# Response to first draft CRISP report on LCN+ Route 8 / Link 250

## London Cycling Campaign in Hackney

Richard Lewis, Trevor Parsons, Brenda Puech, Oliver Schick  
Incorporating comments by Ralph Smyth  
Version 1.0, 6<sup>th</sup> September 2006

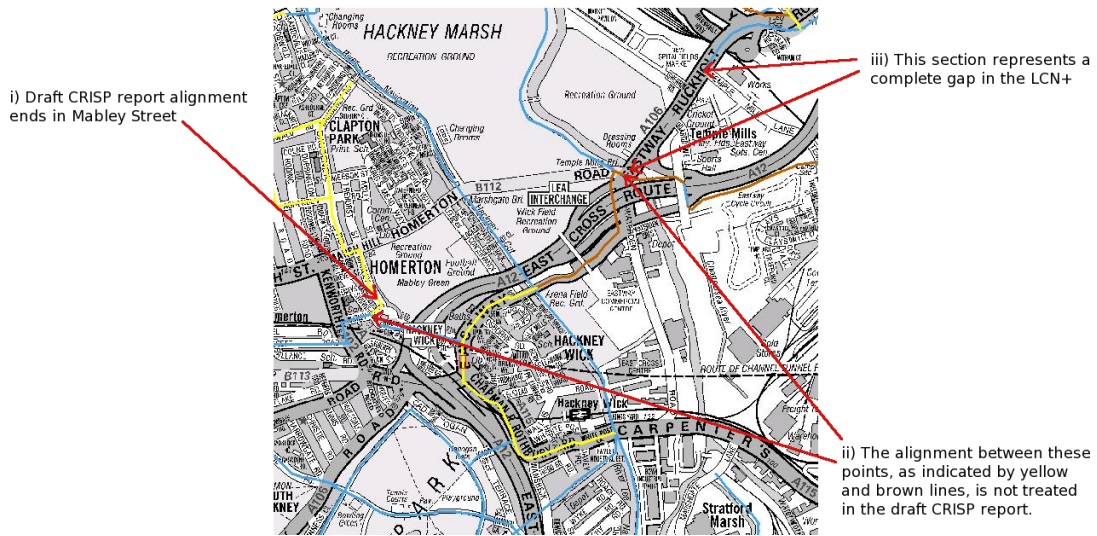
There are other issues and omissions concerning the alignment of this link. For clarity, we have reproduced an annotated map extract from the LCN+ website (see below). There are three sections of the easternmost alignment, each of which receives a different level of consideration in the draft CRISP report.

The first section, (i) on the map below, is the alignment that is discussed in the draft CRISP report as part of the link, effectively the whole distance from Southgate Road to Mabley Street. For an unknown reason, the link, as mapped out on Drawing 2.0, then terminates in the middle of Mabley Street. The ultimate appendix of this link as mapped is not naturally part of any alignment for this link, and the link as mapped there does not even include the Red Path, which at the time of the CRIM and draft CRISP report was certainly part of the alignment of this route. This not only applies to its origins in the LCN alignment, but must also apply to its alignment under the LCN+ programme.

The next section, (ii) on our map, is a stretch that is mapped out in London Cycle Guide mapping and has in the past received some treatment with cycle facilities by Hackney Council. It links Mabley Street with the A12 Lea Interchange via the Red Path and Eastway. The Eastway is a one-way street for some of its length east from the junction with Lee Conservancy Road and contraflow facilities of varied quality are present. This section is not included in the link in the draft CRISP report but has some formal status as LCN alignment in view of its legacy.

Finally, section (iii) on our map links the A12 Lea Interchange with the Waltham Forest borough boundary. This section is not marked in the London Cycle Guides and the vital link to Waltham Forest is missing along this six-lane dual carriageway road. The need for making this section more cycle-friendly is obvious. The excessive motor traffic capacity here has a highly negative impact on Leyton with its one-way system, a negative impact on Hackney, and causes disruption to cycle route alignments. Nonetheless, what is described here as (ii) and (iii) is used by many cyclists from Waltham Forest and Redbridge and in need of an upgrade. It is a priority route that in virtue of its alignment (and few alternatives) attracts higher flows than alternative routes, although in view of the negative road conditions is still under-used.

We strongly recommend that the links in Waltham Forest and Hackney be linked up using sections (ii) and (iii).
